Karuah Quarry Complex
ABN: 15 093 914 937
Hunter Quarries Pty Ltd
Andersite Road, Karuah NSW 2324

RE: Karuah South Quarry (SSD-8795) – Amended Project Application
Hunter Quarries Submission – Review of Implications to Existing Quarry Operations

Figure 1 – Annotated Cross-Section of KSQ (Figure 2.5 – Amended Project Description).

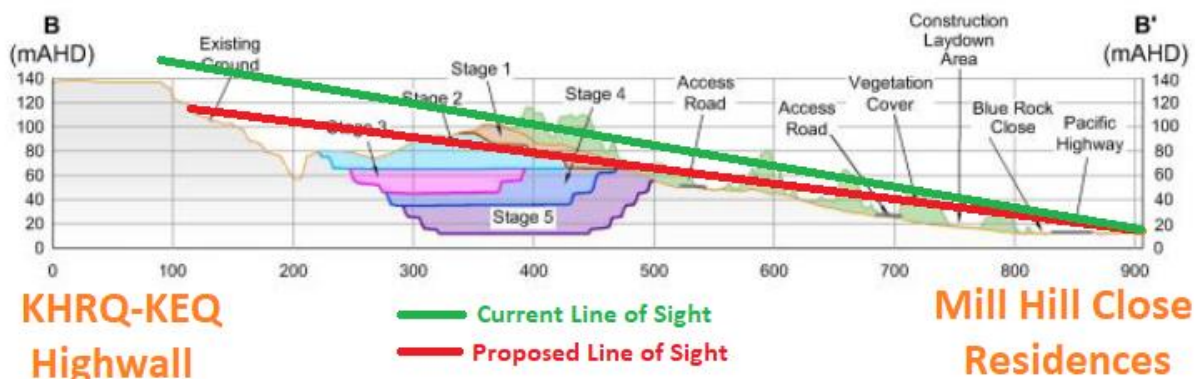
HQPL notes that the proposed KSQ provides a continuation of operations at the existing Karuah Hard Rock Quarry site by extracting the southern benches towards the M1 Pacific Motorway and residential receptors to the south along Mill Hill Close. This extraction will expose the remnant highwall between the Karuah Hard Rock Quarry & Karuah East Quarry as illustrated by the annotated cross-section provided by **Figure 1**.

This view of the final landform will have an adverse impact on the residual landscape of the Karuah East Quarry for both Mill Hill Close residential receptors and for vehicles along the M1 Pacific Motorway. The Department should consider substantially reducing this impact by requiring removal (or lowering) of the remnant highwall between the Karuah Hard Rock Quarry & Karuah East Quarry.

7.1. HQPL requests the Planning Secretary provide consideration of extraction sequencing to minimise adverse visual impacts by requiring the remnant highwall to be removed (or lowered) prior to the commencement of the KSQ project.
